ADDENDUM NO. CC-2

March 16, 2026

Lewis Central Community School District
Athletic Building Addition & Renovation
3820 Harry Langdon Blvd, Council Bluffs, IA 51503
BCDM Project No. 5551-05

NOTICE TO BIDDERS: The Project Manual and Drawings for the above-mentioned project are hereby amended as follows:

2 FLOOR PLAN - UPPER LEVEL
1/8" = 1'-0" 0' 8' 16'

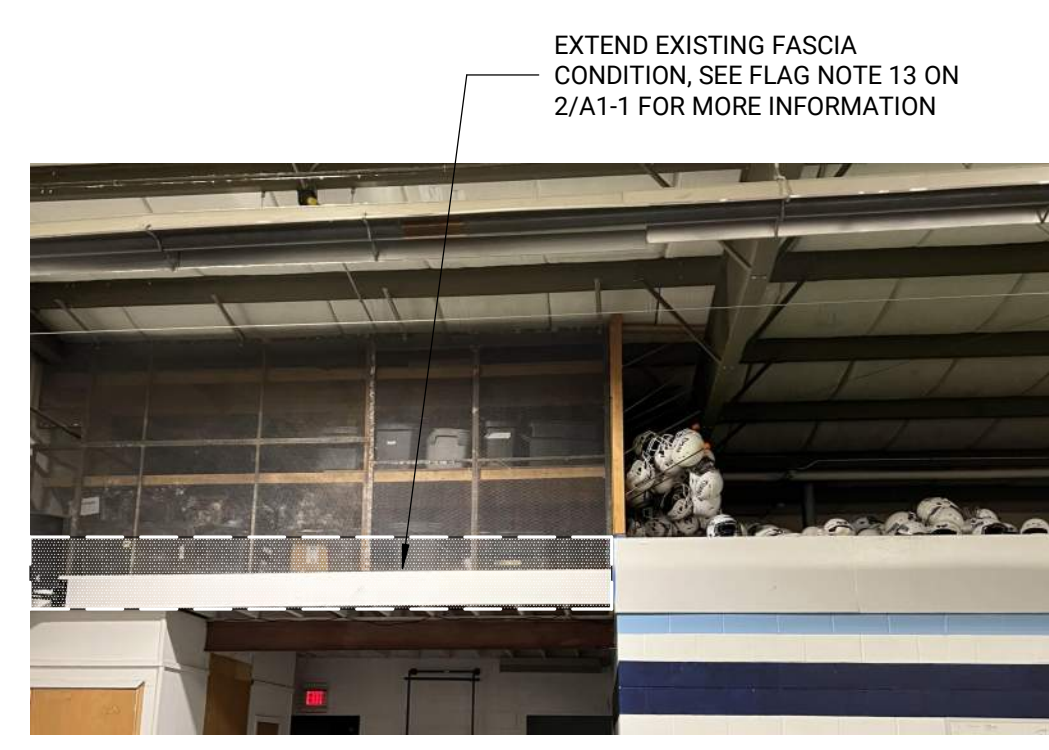
- a. See detail 2/G0-1 on the attached sheet for revisions at the Upper Level Athletic Storage. Upper Level Athletic Storage has been removed and replaced with wrestling mat storage lifts.
- b. See attached Sheet G0-1 for revisions to the Maximum Common Path of Travel due to the Upper Level Athletic Storage being removed.

6 SECTION - STAIR ST-02 LOOKING EAST
A1-4 1/4" = 1'-0" 0' 1' 4' 8'

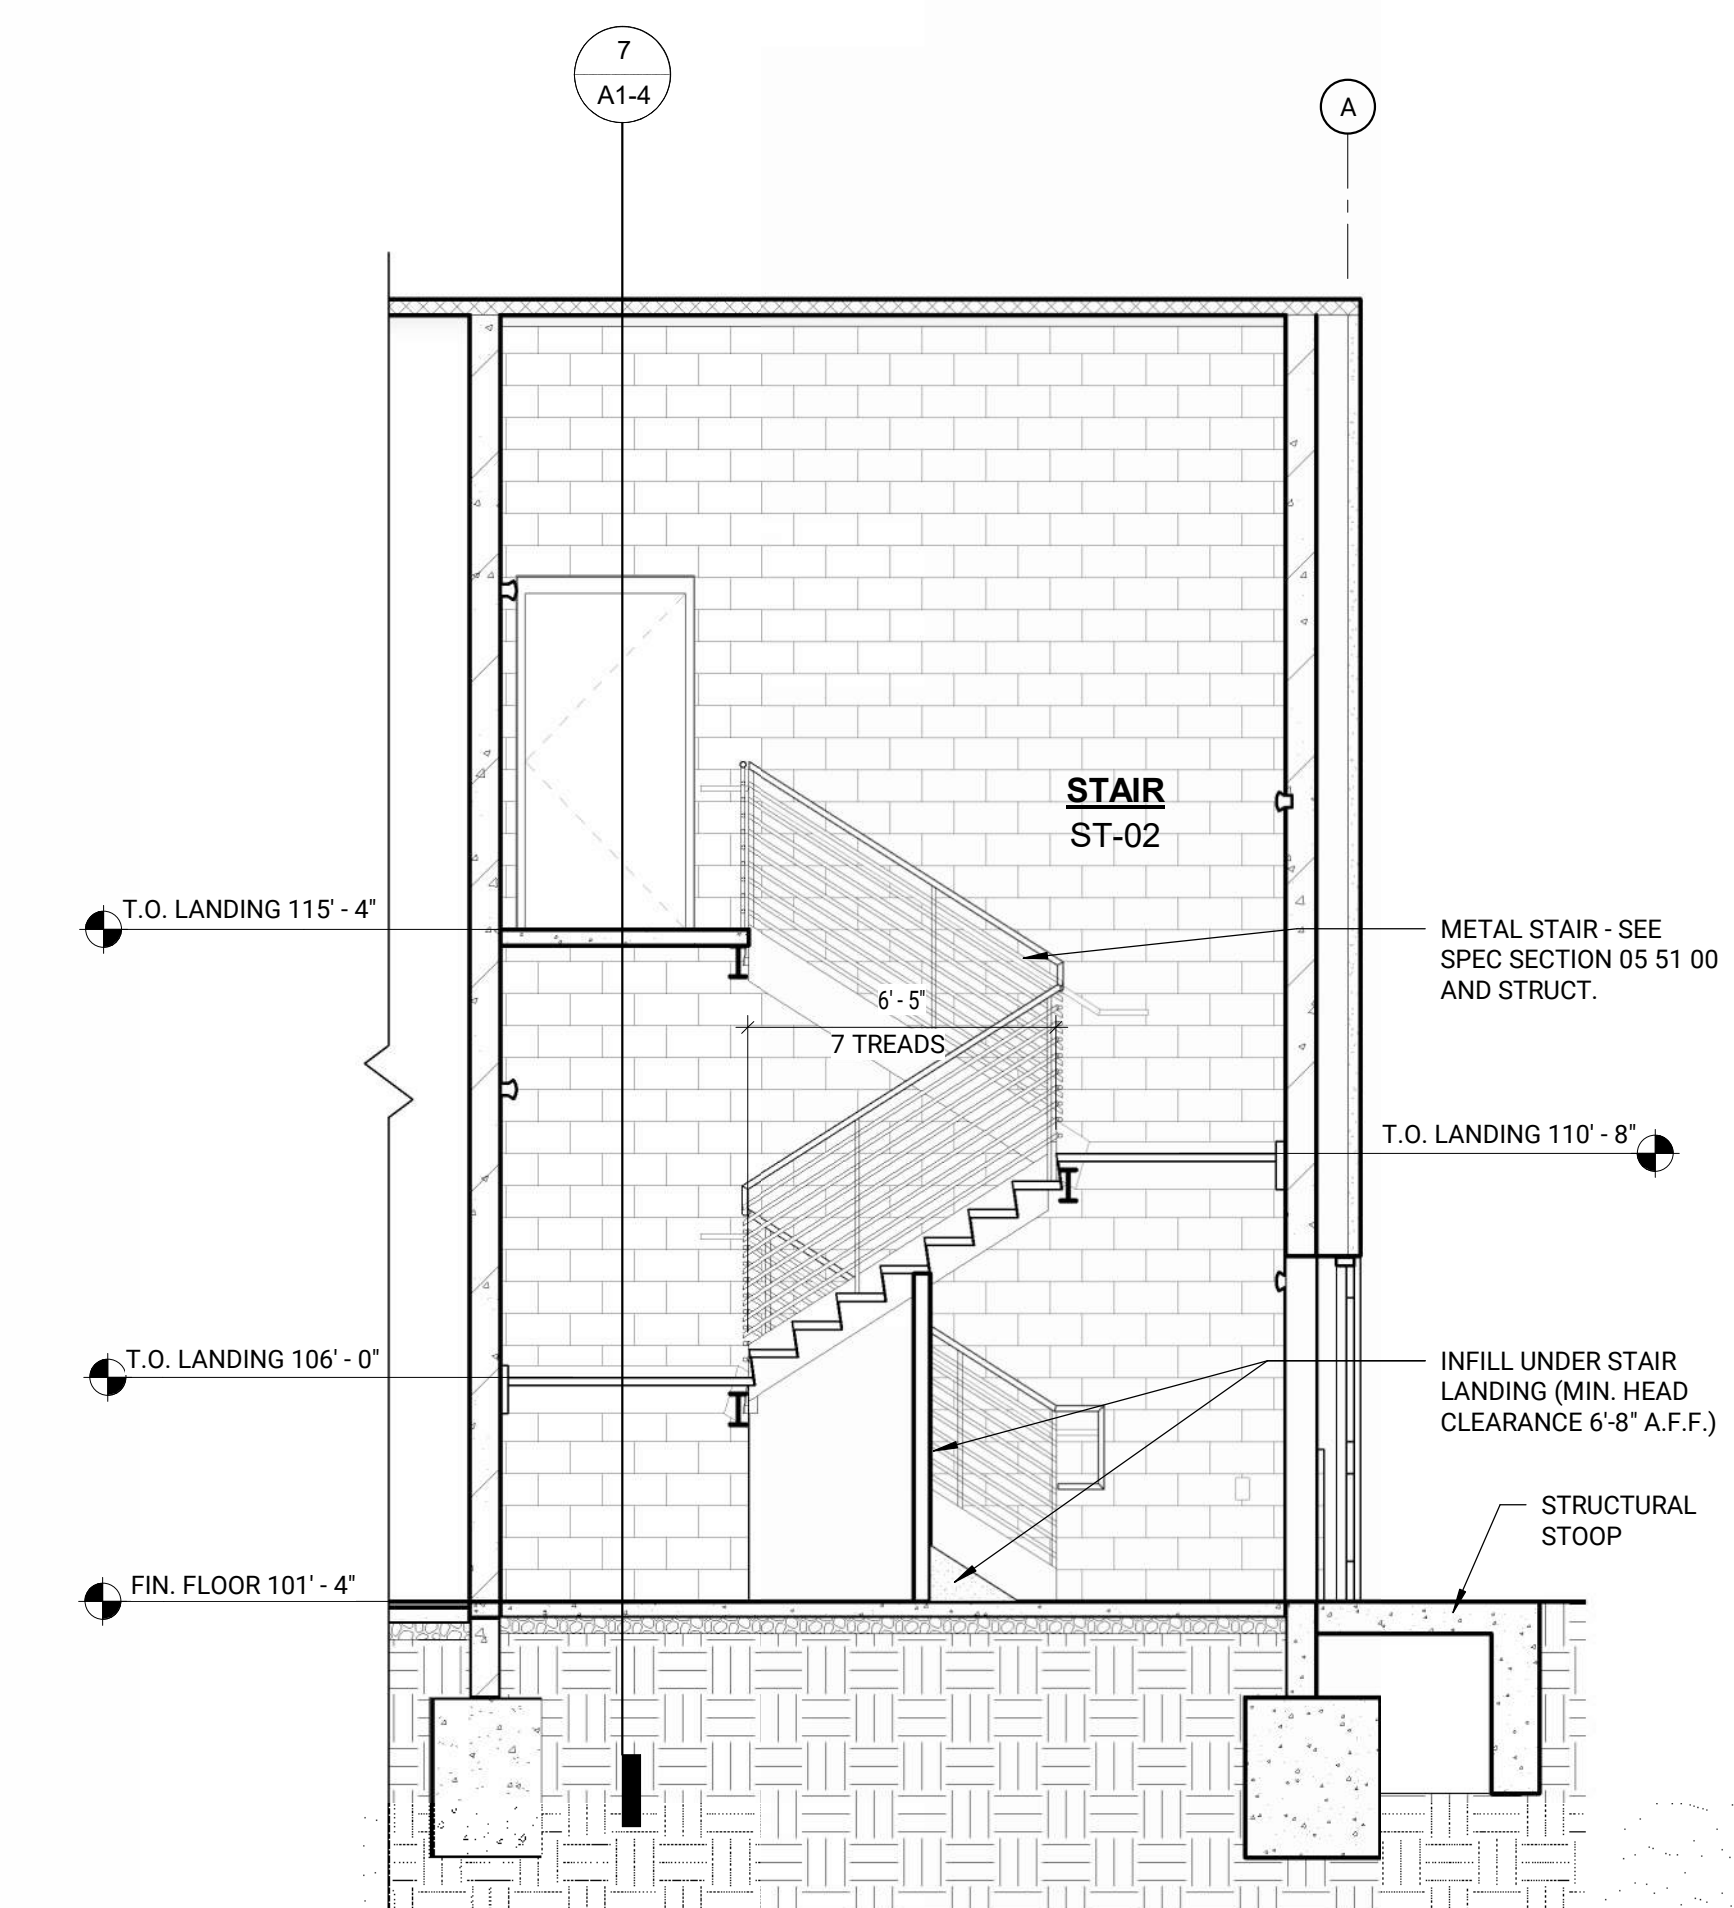
- a. See detail 3/A1-4 on the attached sheet for revisions at the top of Stair ST-02.
 1. Delete door 201.
 2. Delete top landing and top run of stair.
 3. Add guardrail at landing adjacent to door 200.
- b. See detail 6/A1-4 on the attached sheet for revisions at the top of Stair ST-02.
 1. Delete top landing and top run of stair.
 2. Add guardrail at landing adjacent to door 200.
- c. See detail 7/A1-4 on the attached sheet for revisions at the top of Stair ST-02.
 1. Delete top landing and top run of stair.
 2. Add guardrail at landing adjacent to door 200.

DOOR AND FRAME SCHEDULE

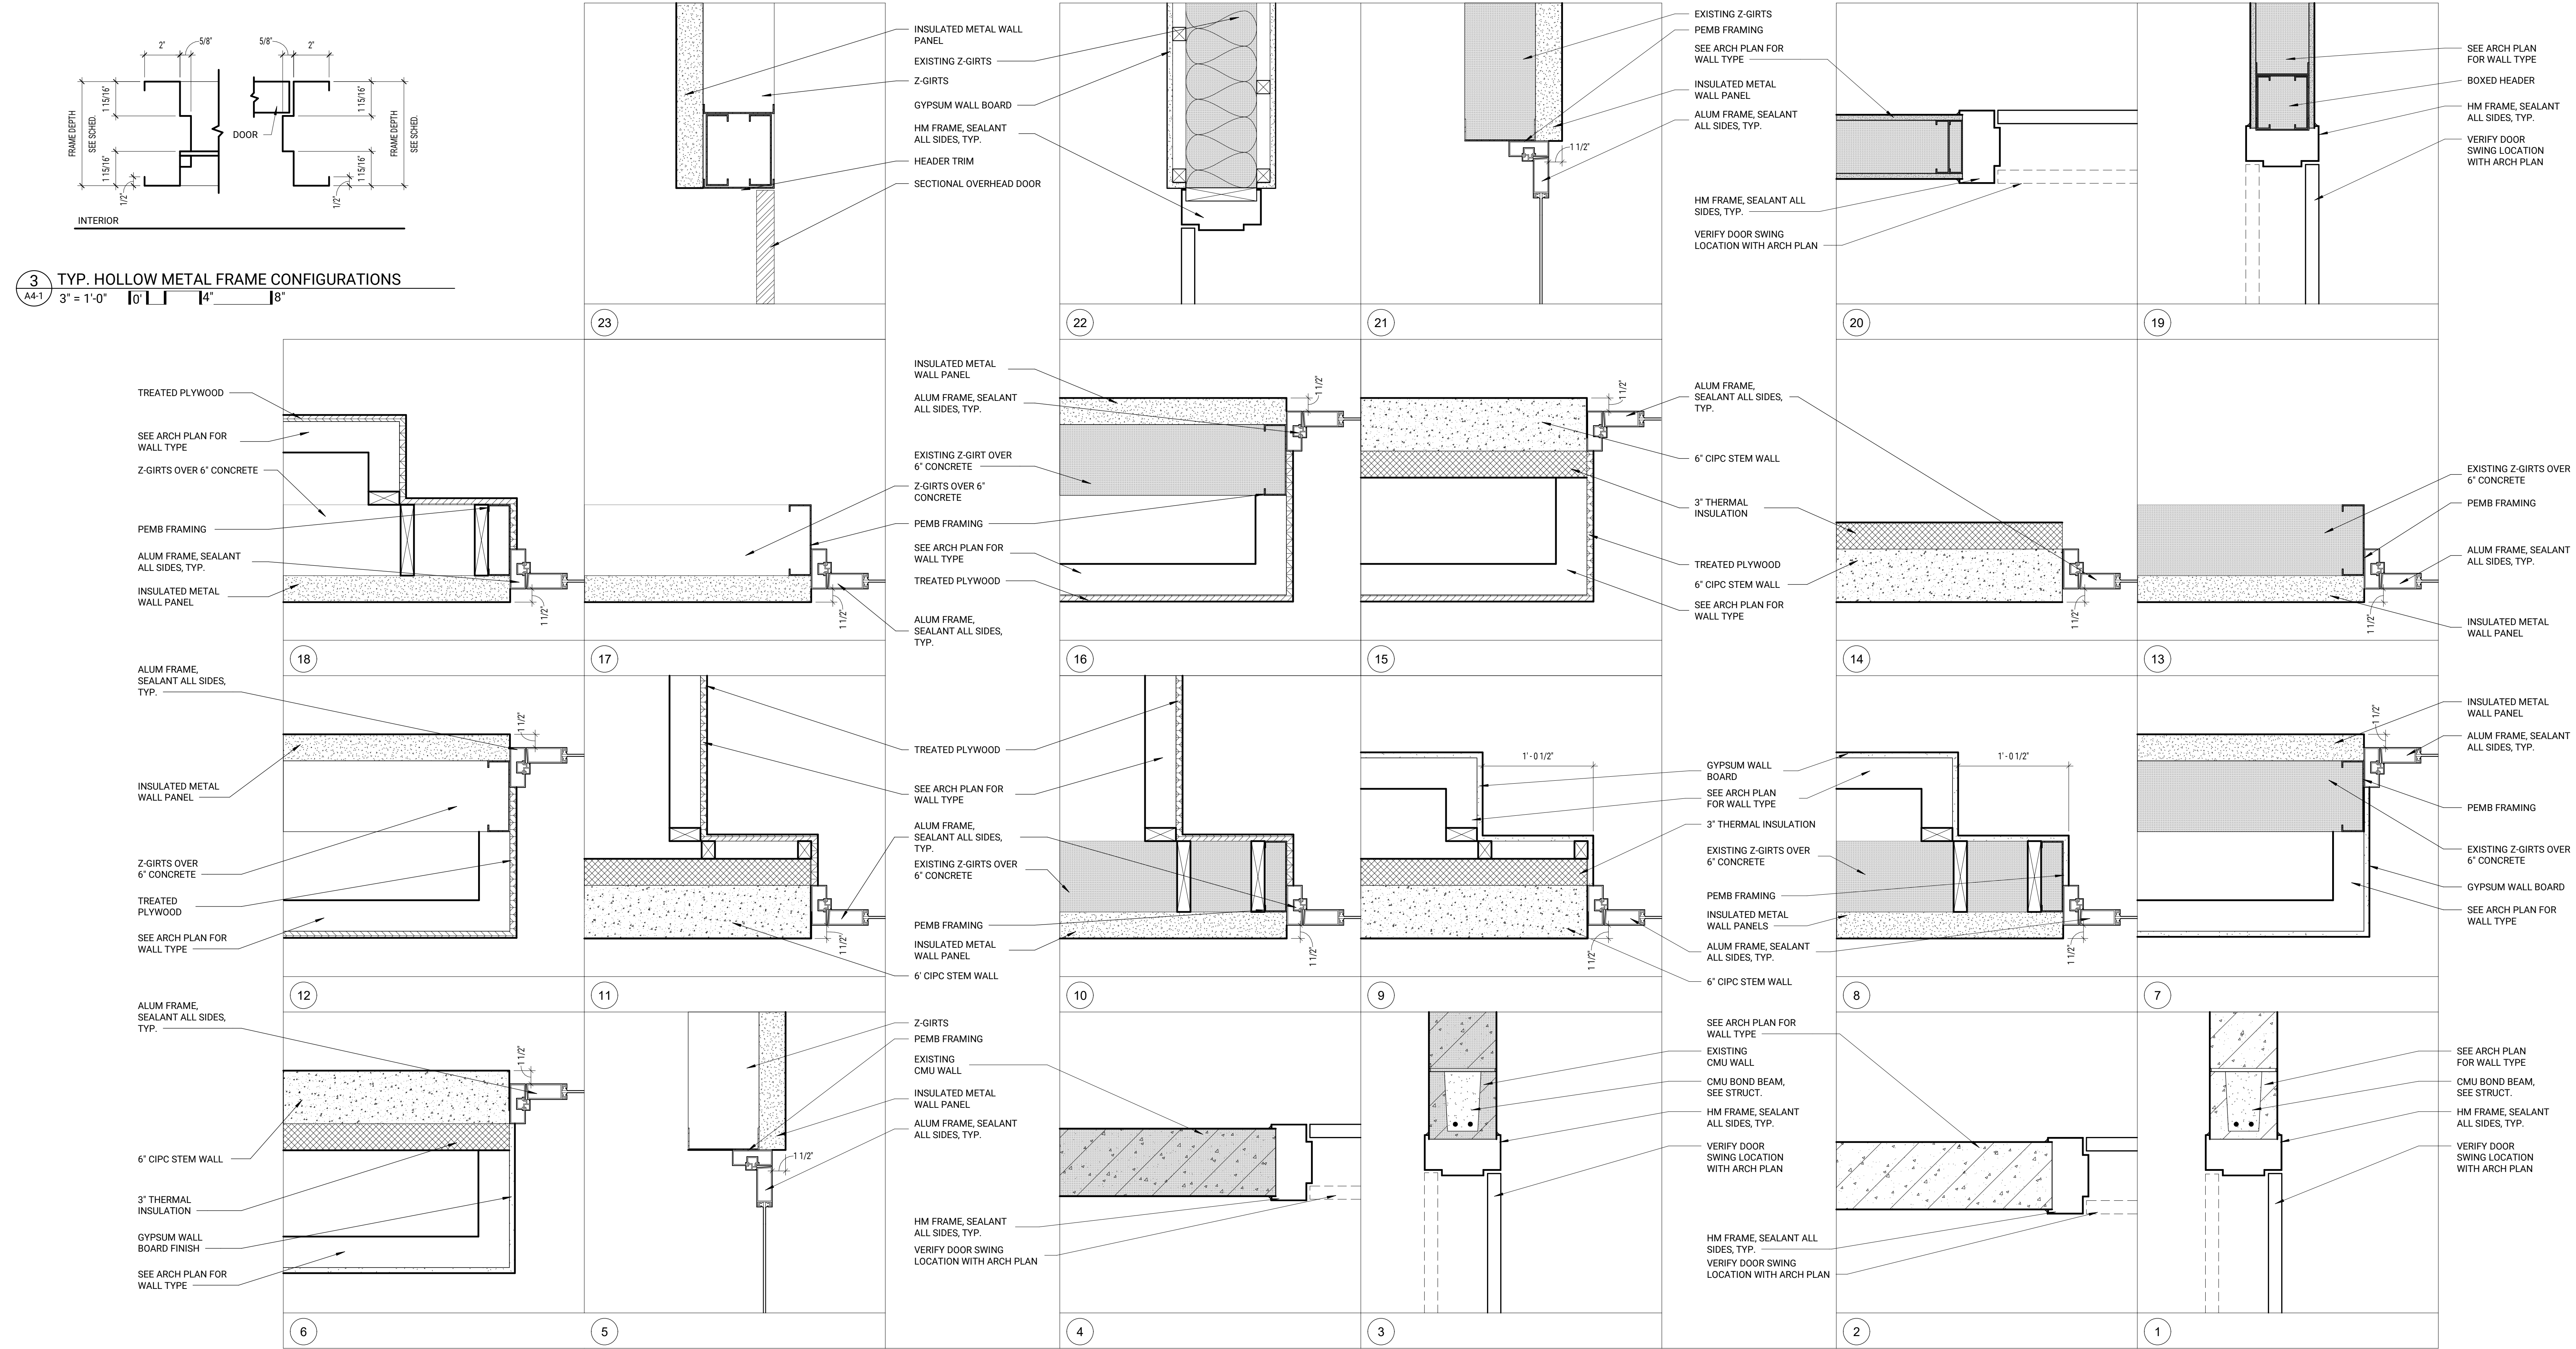
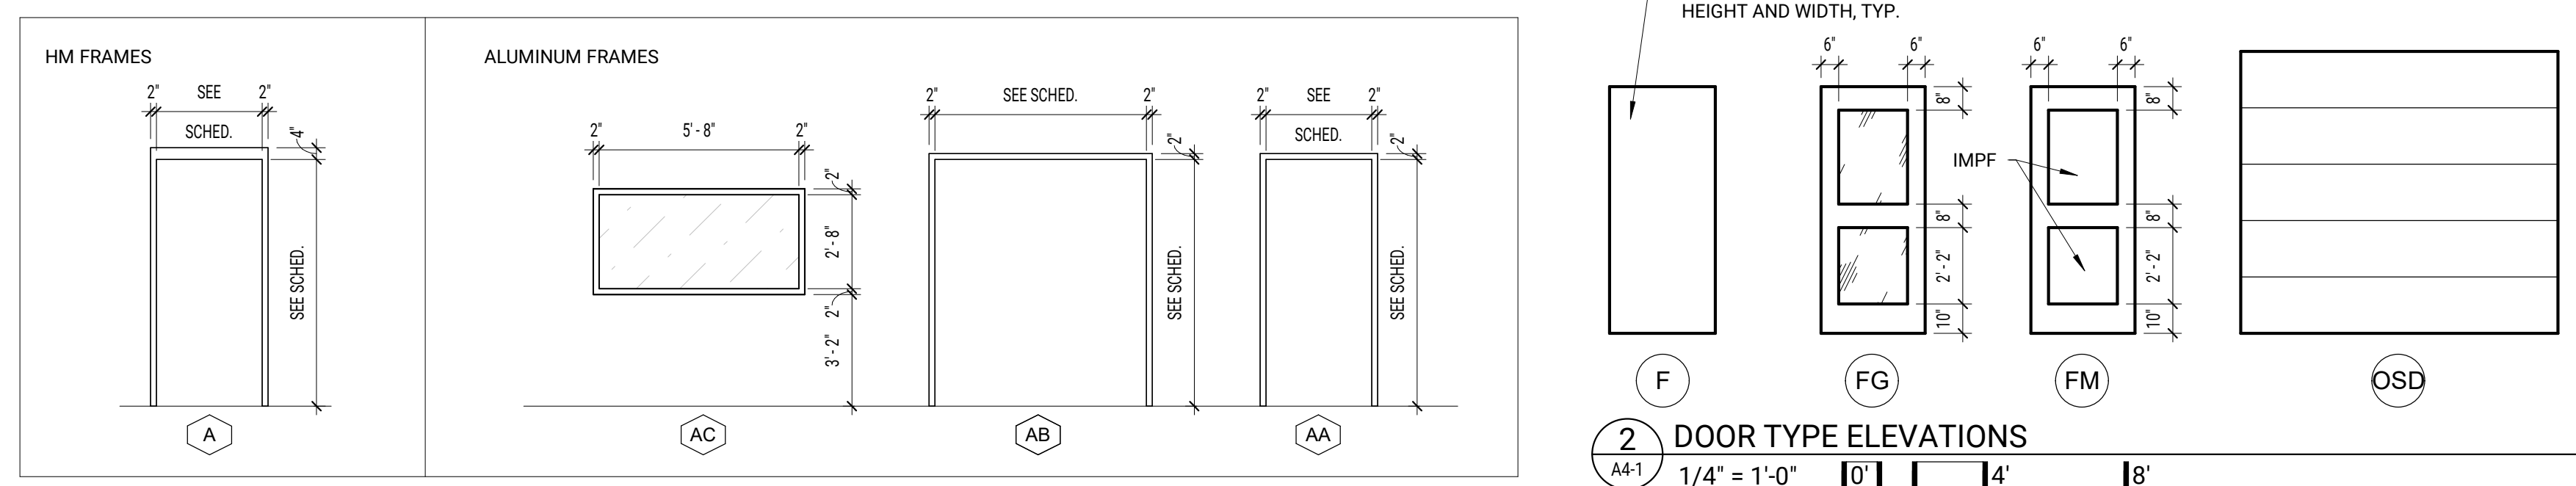
- a. Delete Door 201 from the Door and Frame Schedule.

DELETE DOOR 201 FROM THE DOOR AND FRAME SCHEDULE 2
